LOCAL HISTORIC DISTRICT:	Wilmore
PROPERTY ADDRESS:	1617 Wilmore Drive
SUMMARY OF REQUEST:	Addition
APPLICANT/OWNER:	Shawn and Alyssa Cox

Staff Analysis

HDCRMA 2019-00393 PID: 11908114 LOCAL HISTORIC DISTRICT: WILMORE PROPOSED PROJECT: ADDITIONS September Meeting 2019

Front & Rear Elevations - Existing and Proposed

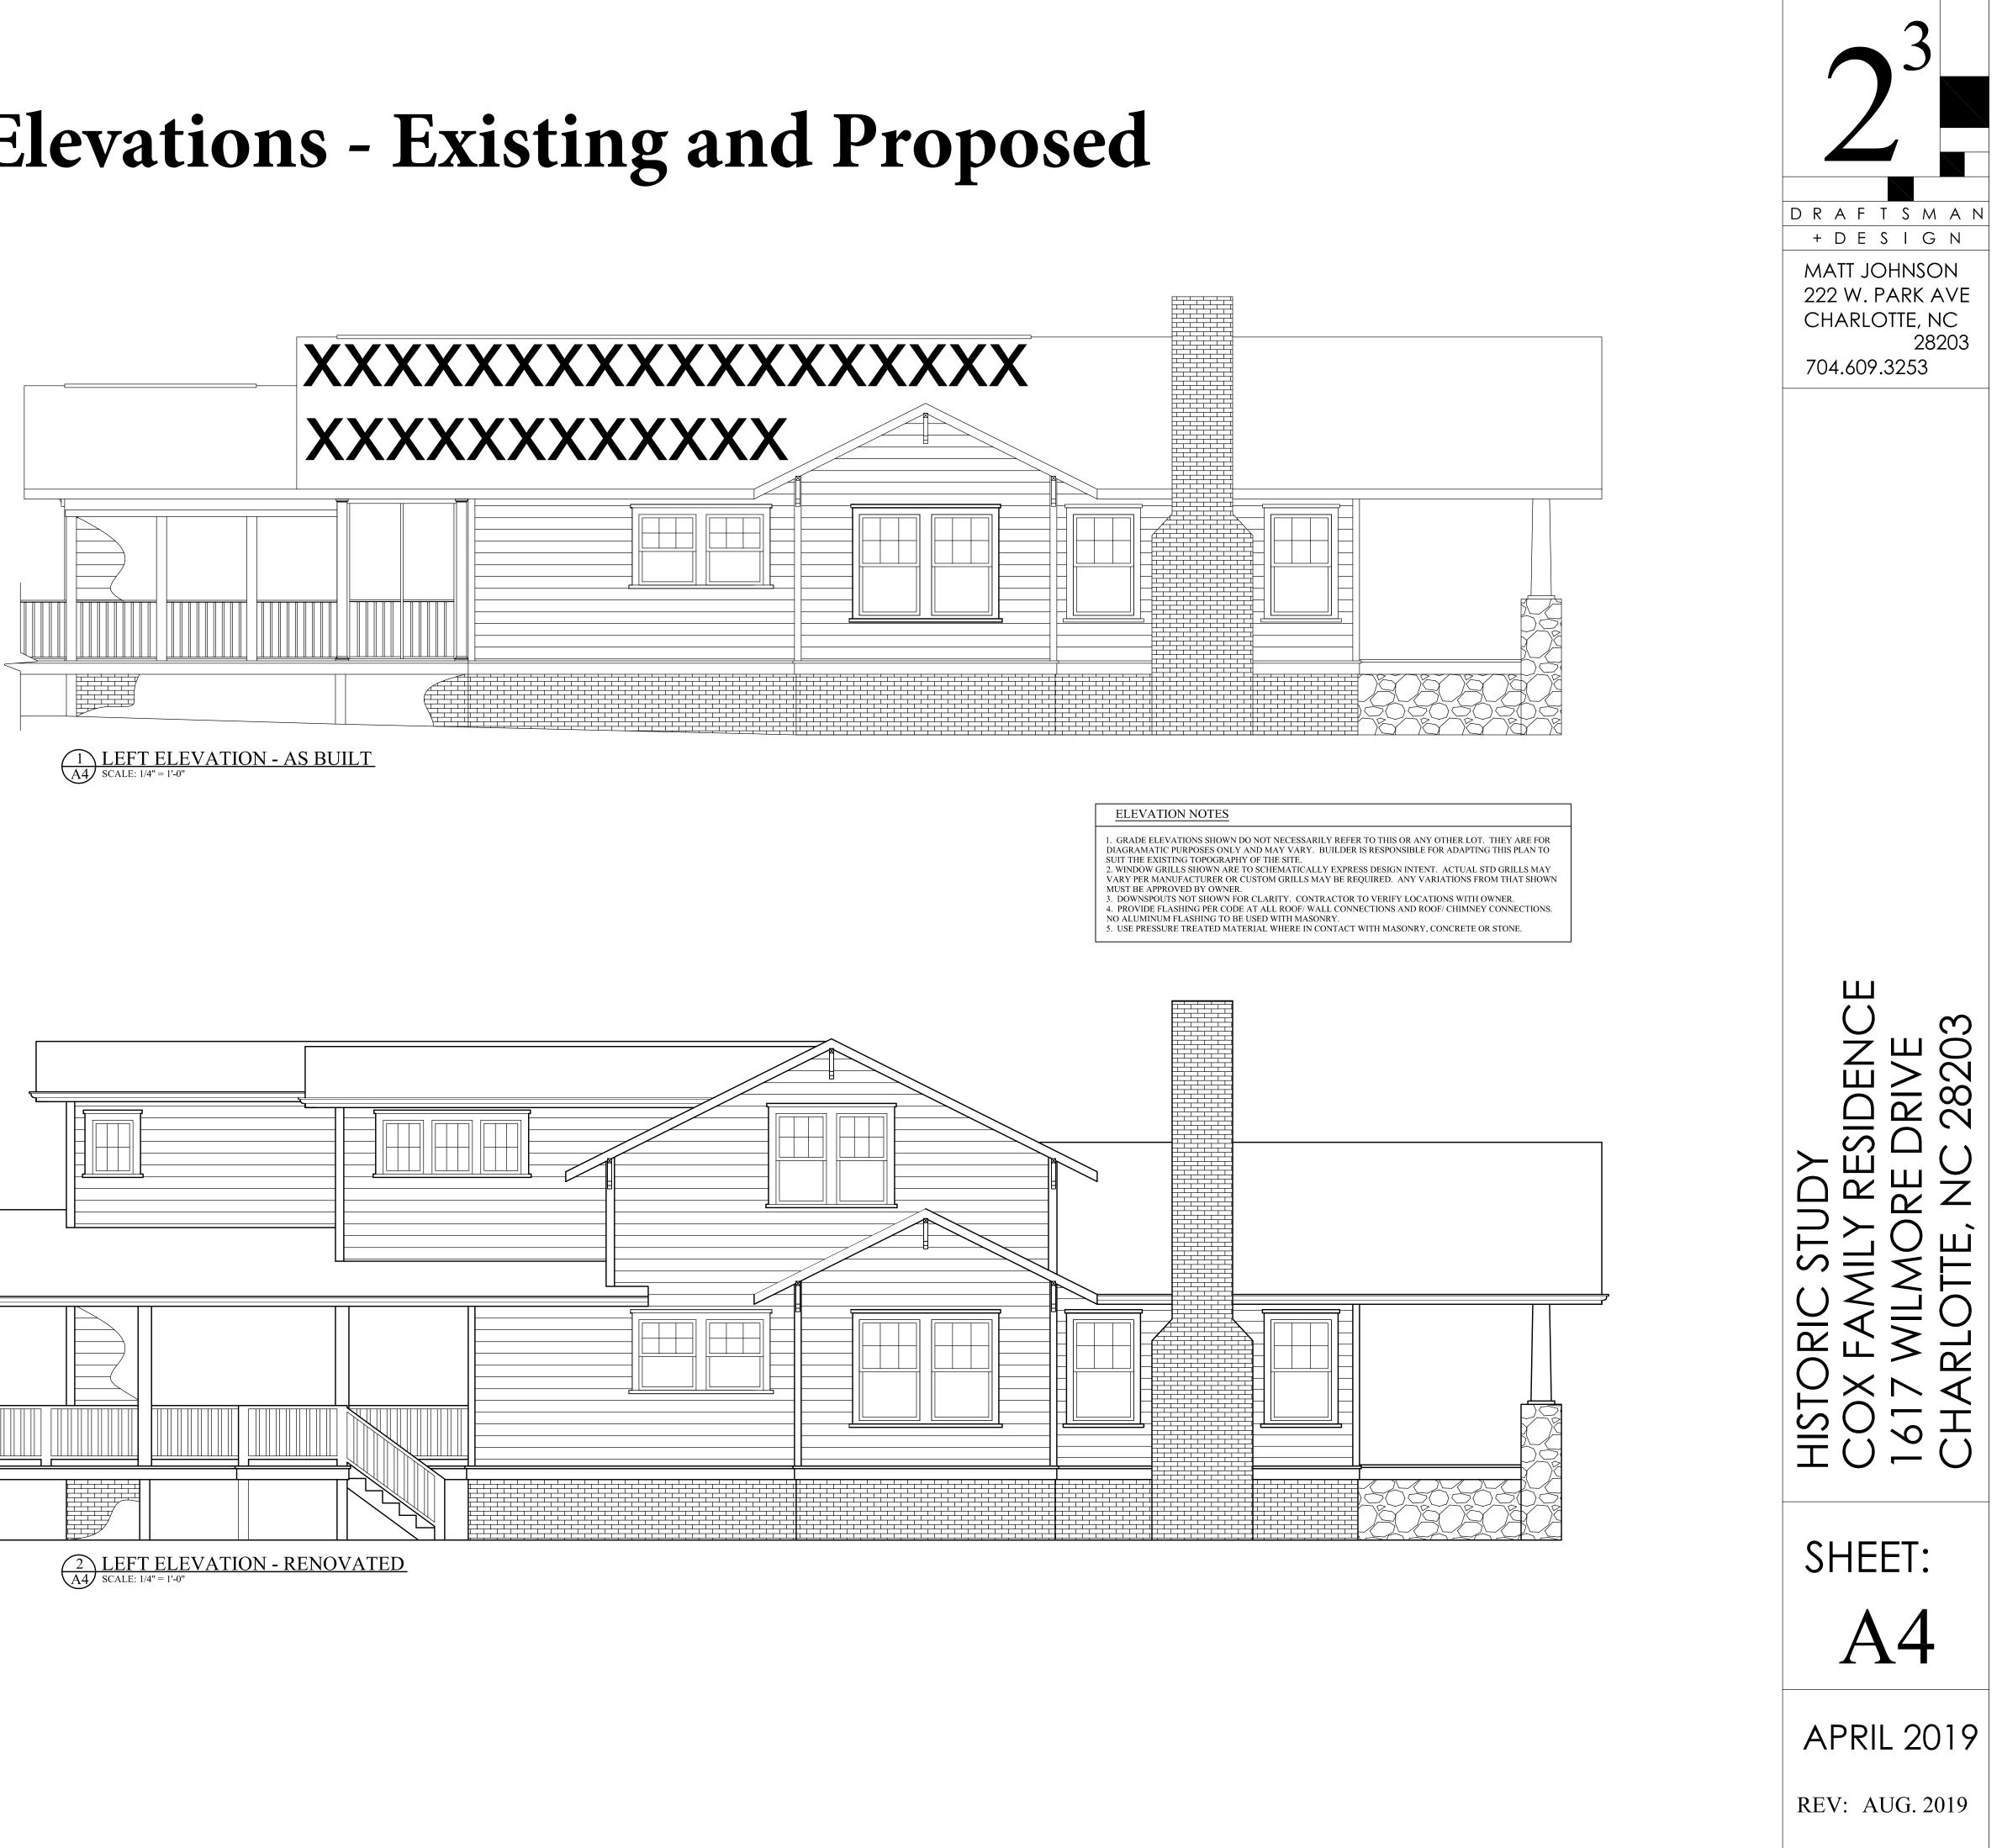
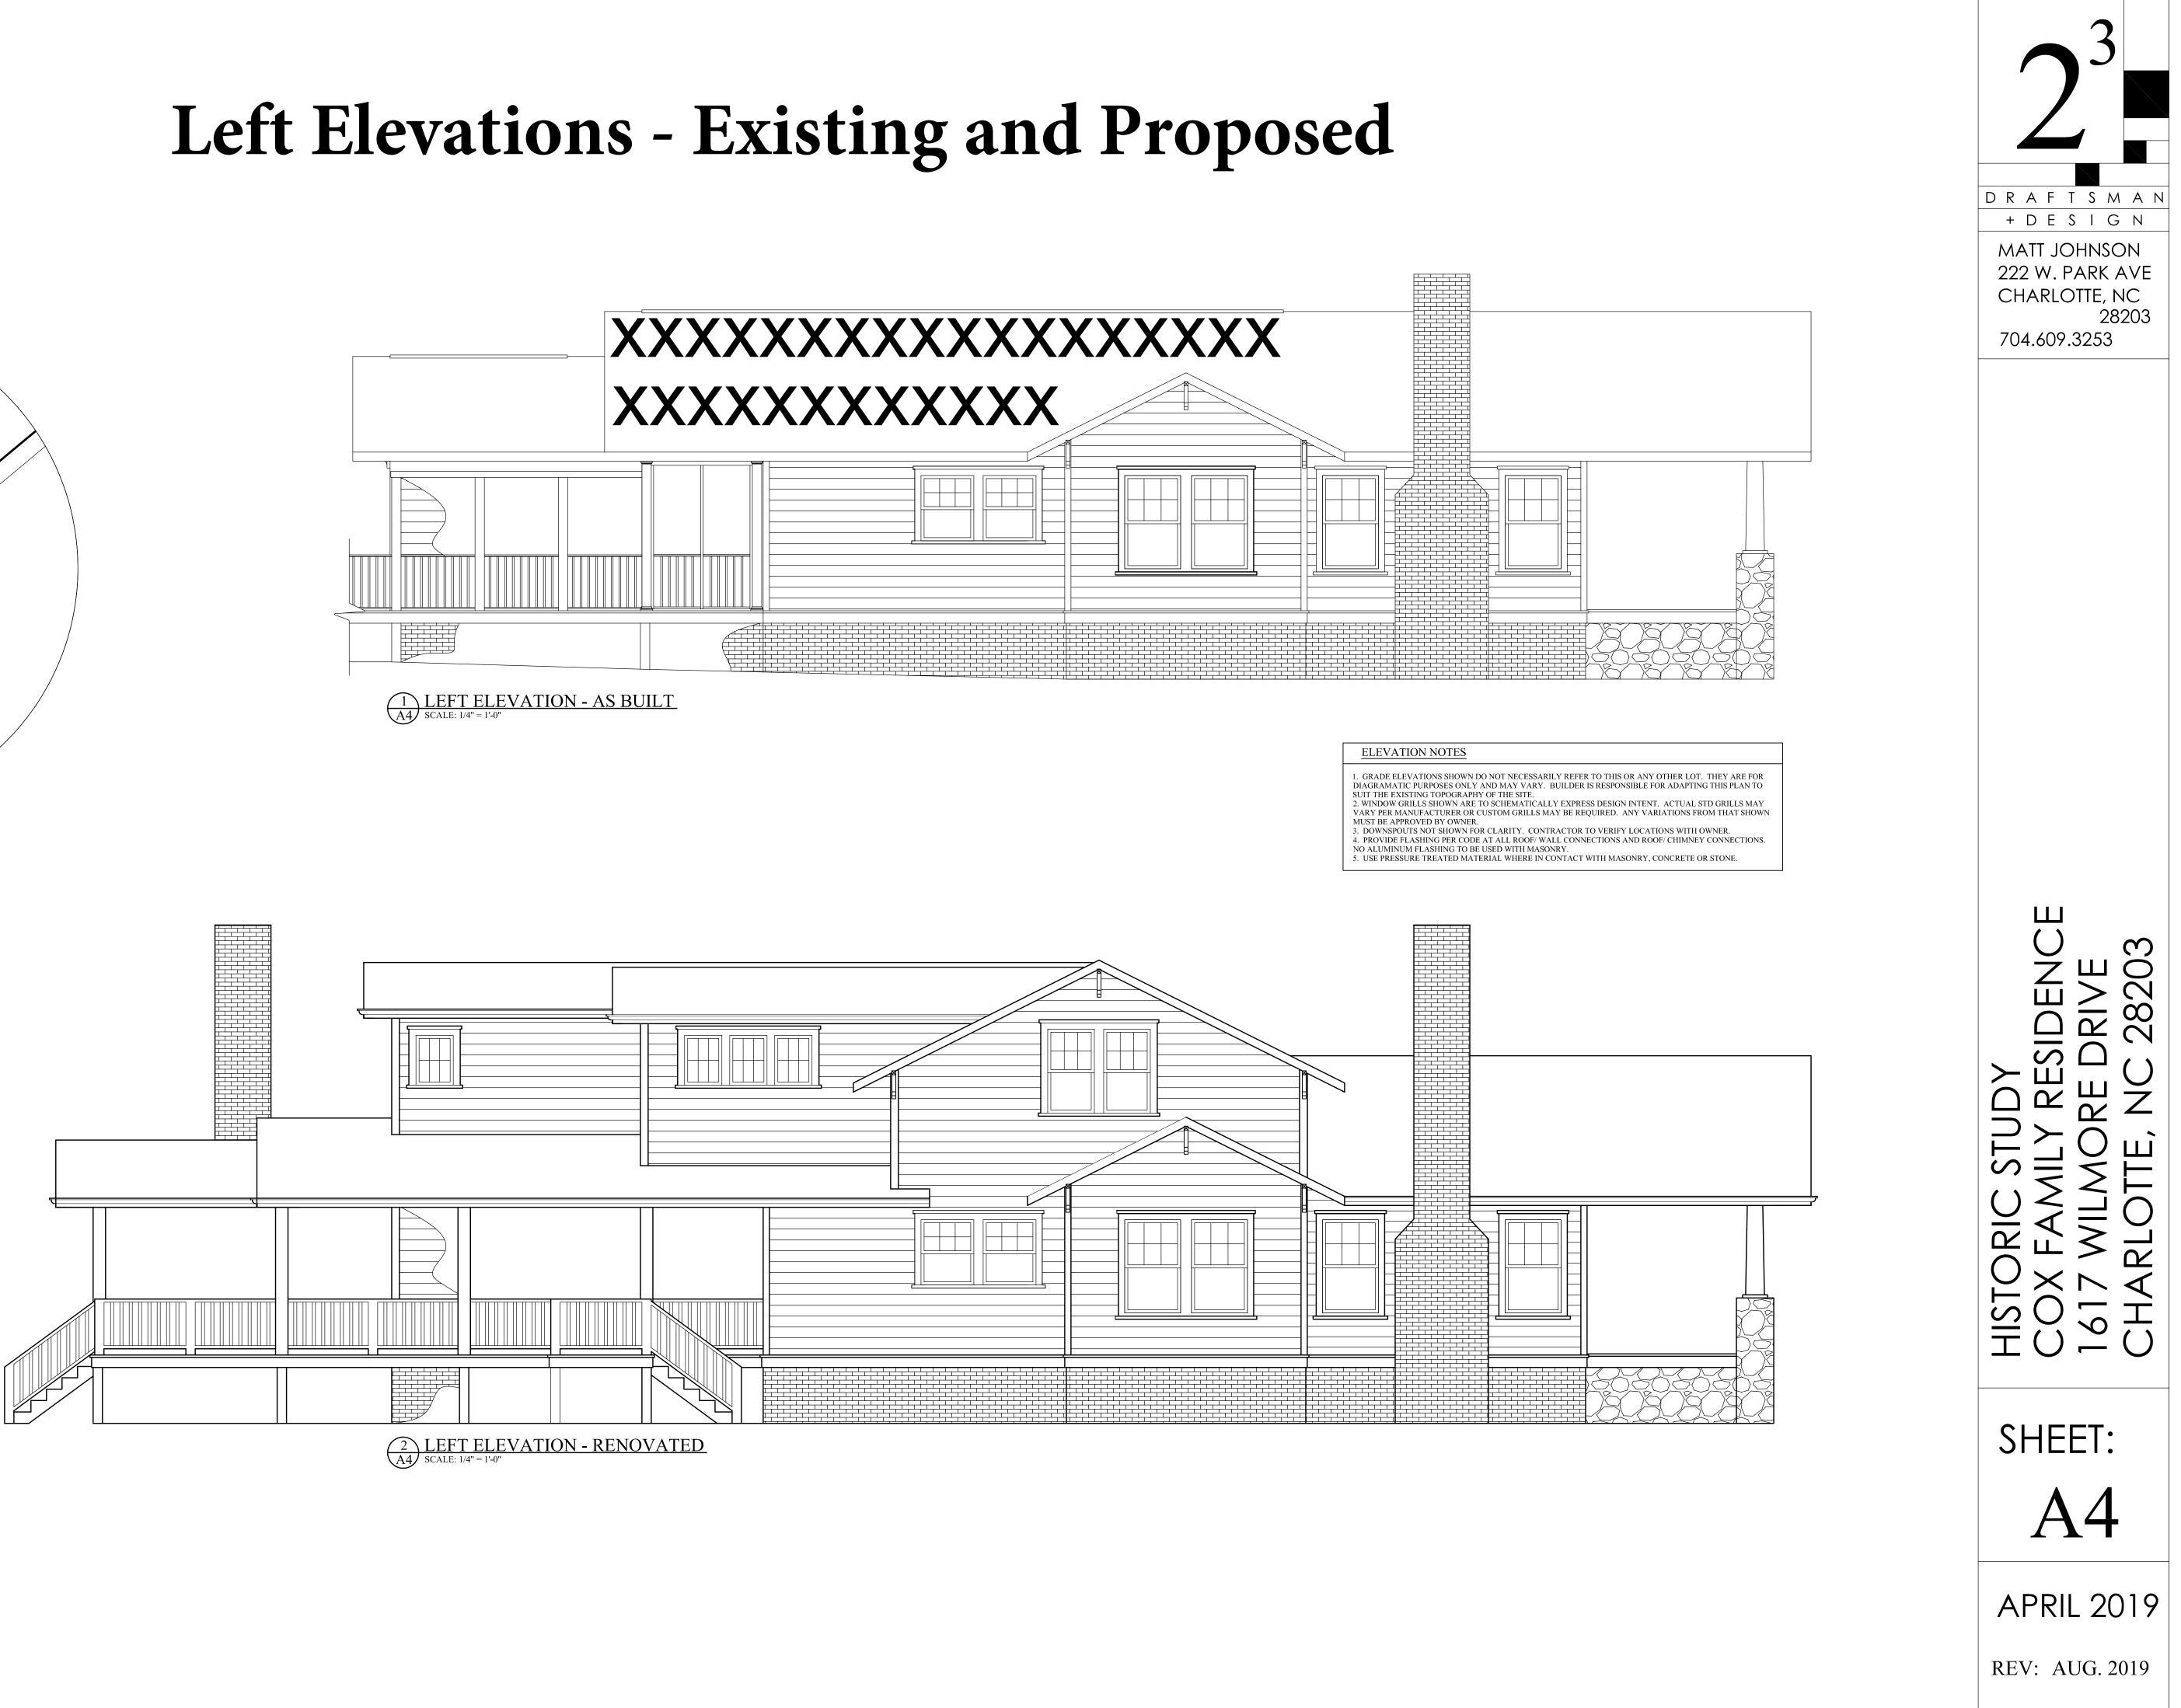
- 1. Height increase from 18'-2' to 23'-8 ½".
- 2. Addition is co-planer on left, right, and rear elevations creating two-story walls.
- 3. Roof form on right elevation.
- 4. Rear yard open space calculations not provided.
